## MFD NON-COMPLIANCE REPORT # 30216-52

PART NAME: **COOLING BRIDGE**  
PF/SA NO.: **PF-391-125-31 R0**  
WORK ORDER NO.: **30216-52**  
VENDOR **OSV (E&S Precision Machining)**

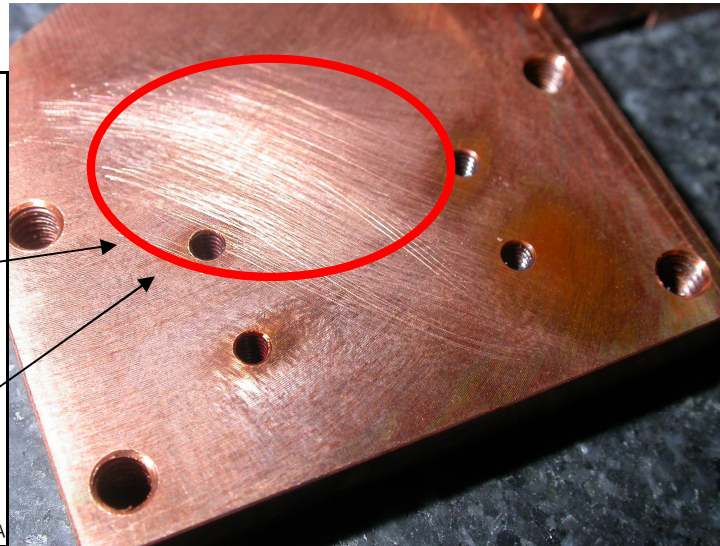
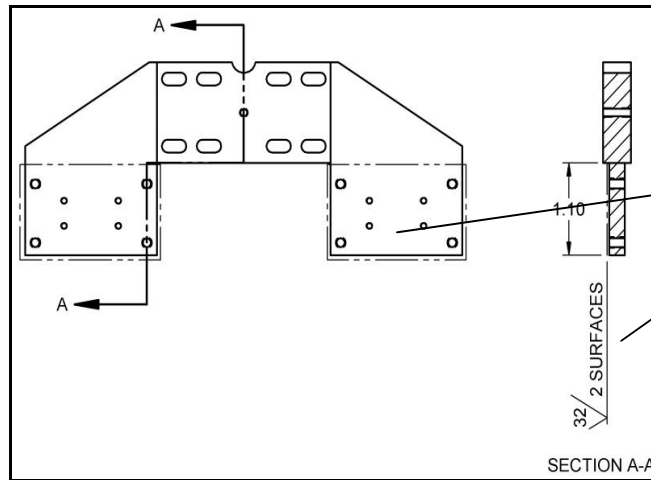
1.  $\sqrt{32}$  SURFACES measures 60.0 & 65.0 on both surfaces & on both Parts. Surfaces have scratches (See Images Below for Location/Clarity).
